Piedmont Recreation Pickleball Subcommittee
c/o Erin Rivera, City of Piedmont

Re: Oct. 7, 2019 Hearing

Hampton 12:30

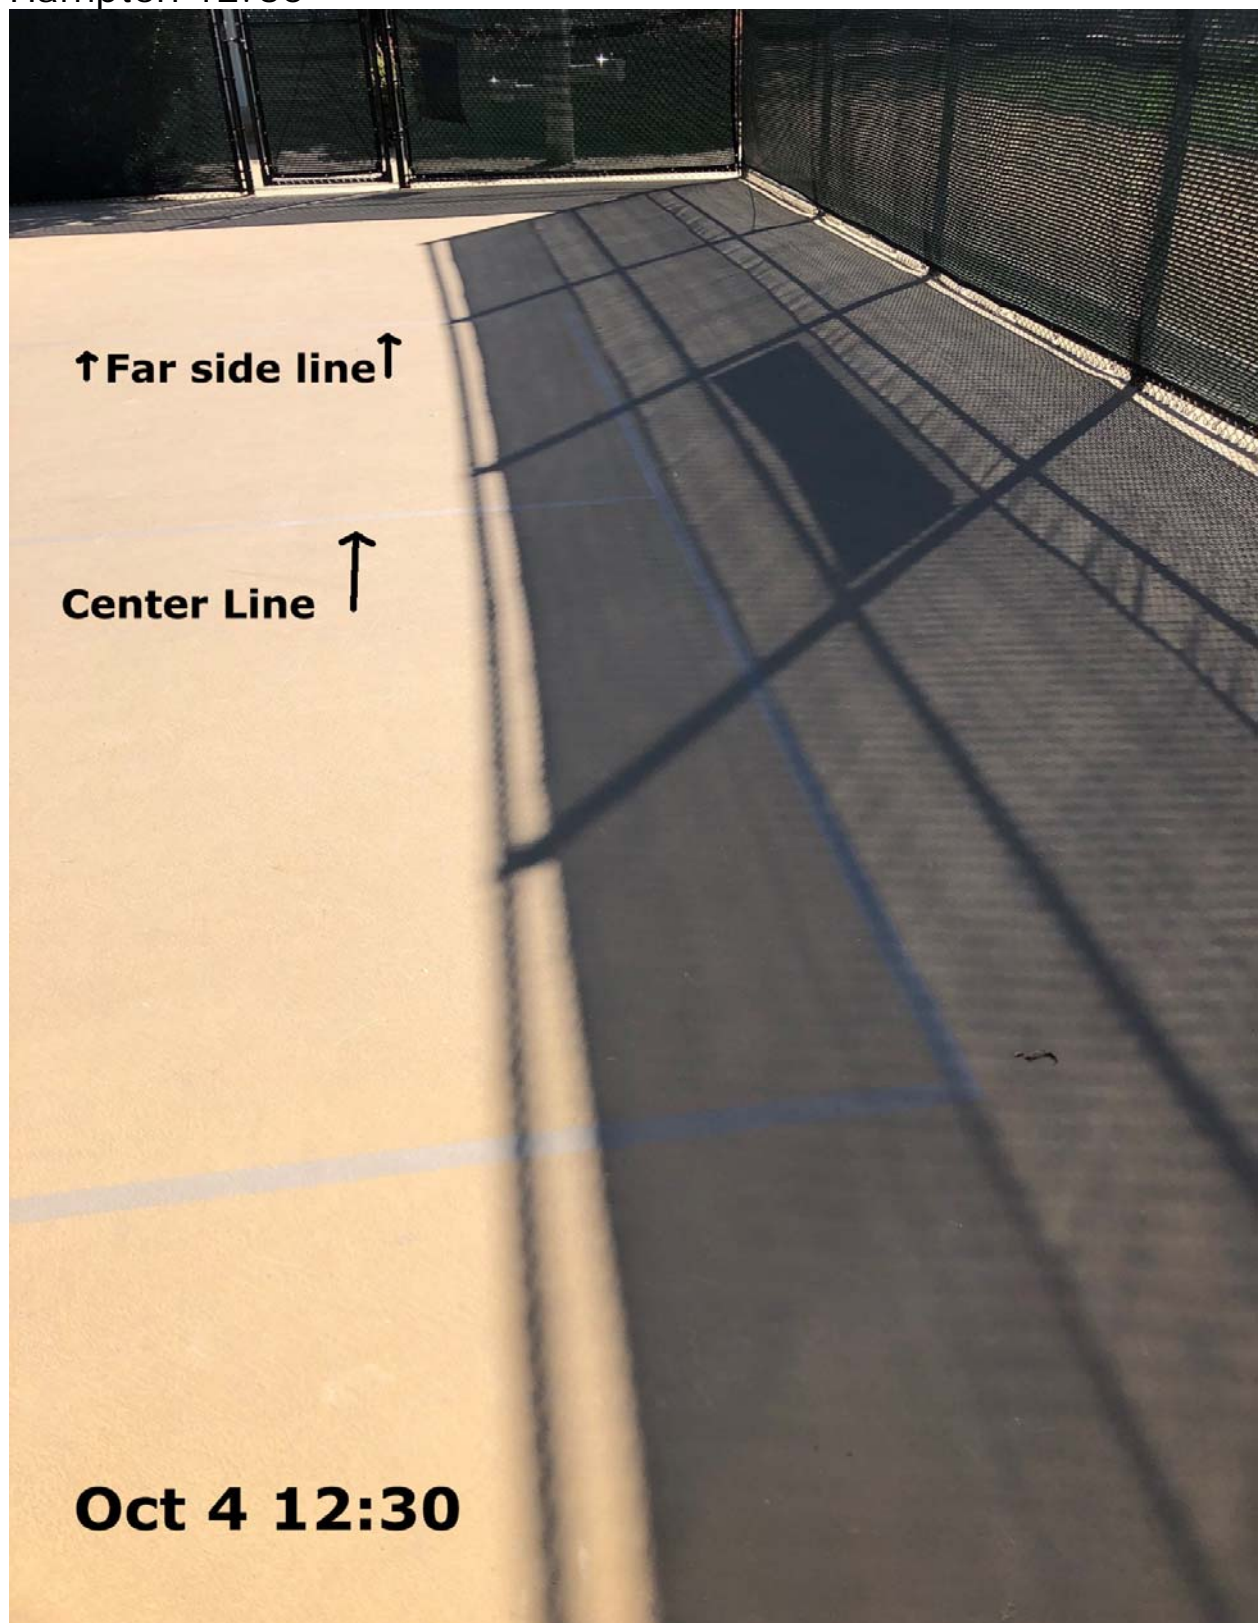
III. The overly light brown Hampton pickleball lines on the tan surface are difficult and the two courts next to the baseball field become effectively unusable as shadows obscure the baselines (see two photos). Darker lines should be installed. Additionally permanent net placement marks are needed at Linda and Hampton. While usable, the Linda pickleball lines could be a bit darker.

Piedmont Middle School

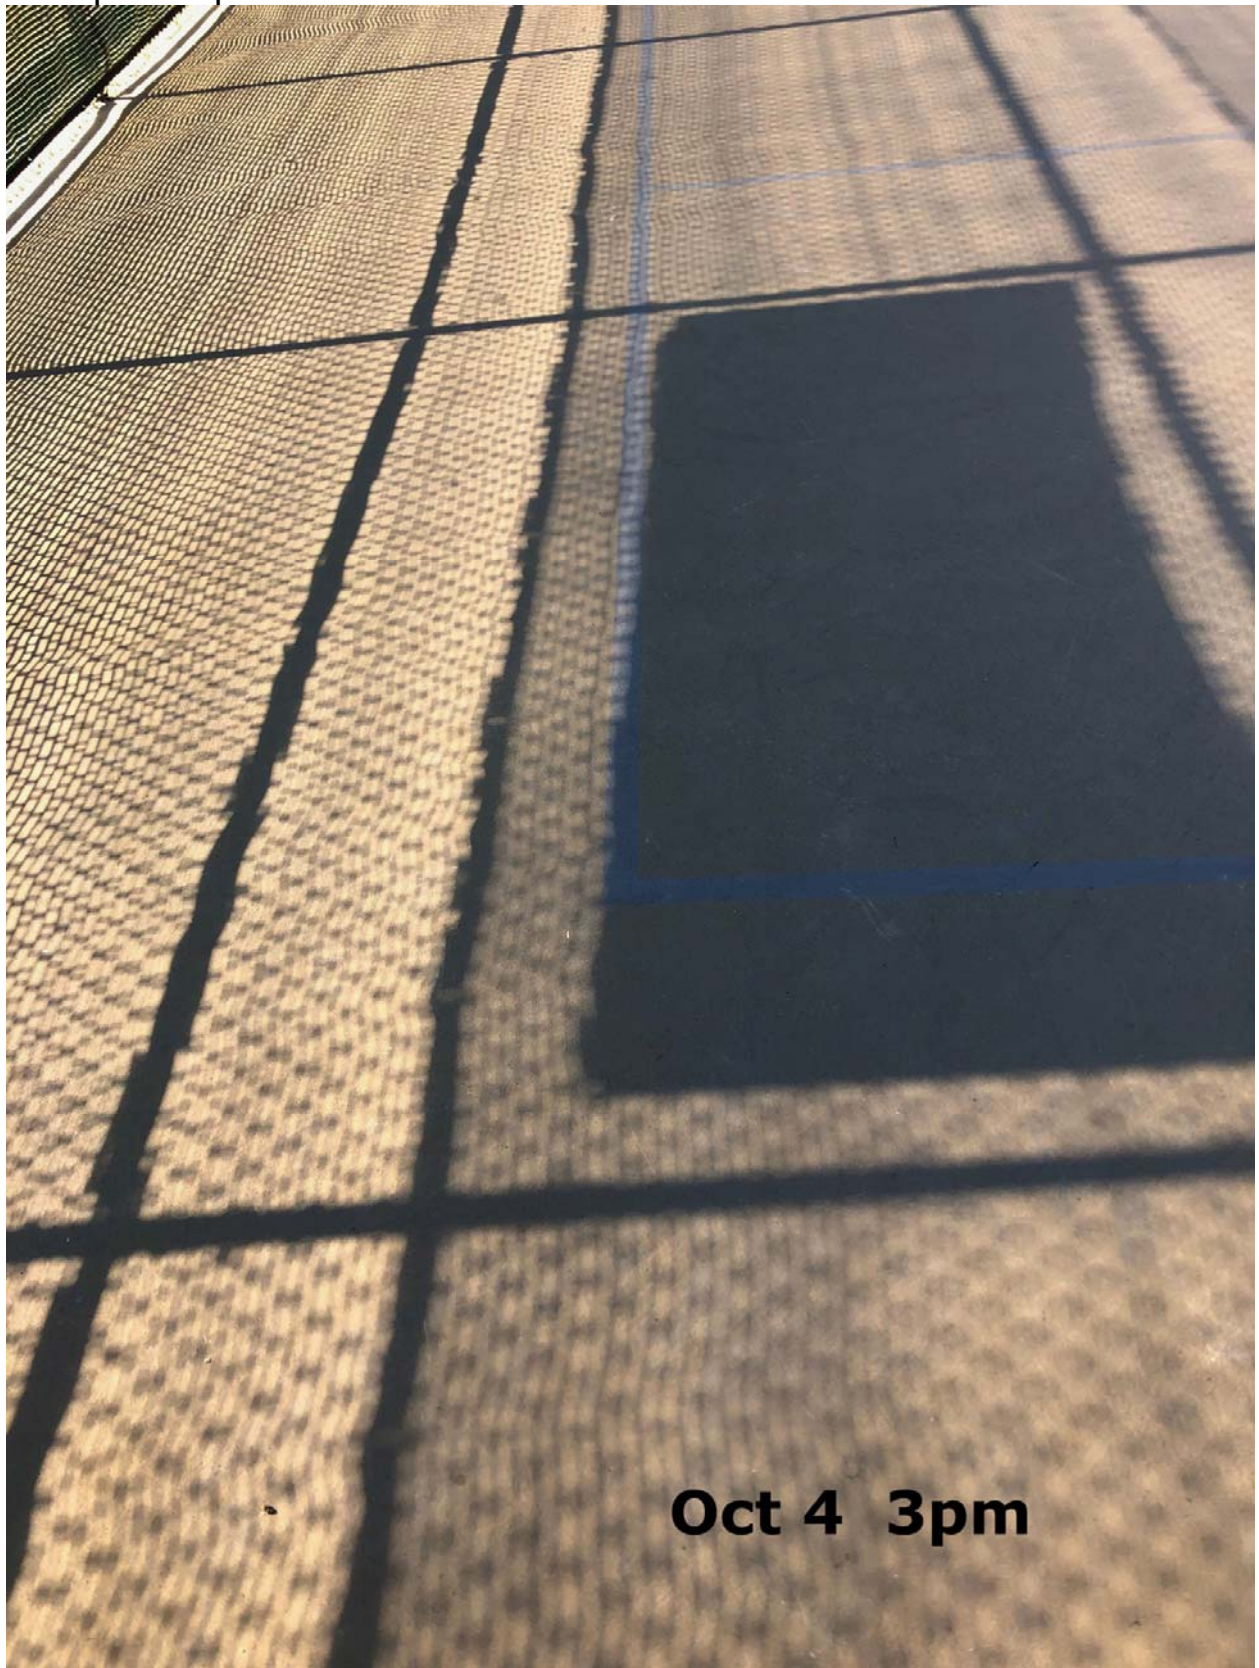
The Badminton World Federation Handbook II 2014/15 Section 1A states badminton court striping is 40mm / 1.6" (see Badminton World Federation Sec 4.1 p1 attached). PUSD striped their PMS badminton lines twice as wide at 83mm or 3.25" (see att.). The paint used by the District has an unneeded three dimensionality to it and the lines are not sharp.

I am disappointed in the District's unilateral action. If a redo is possible, the four pickleball courts on the first two badminton venues can be restriped about two feet closer to each other so the existing basketball poles are less of an obstruction; they are in issue now if balls are hit near them.
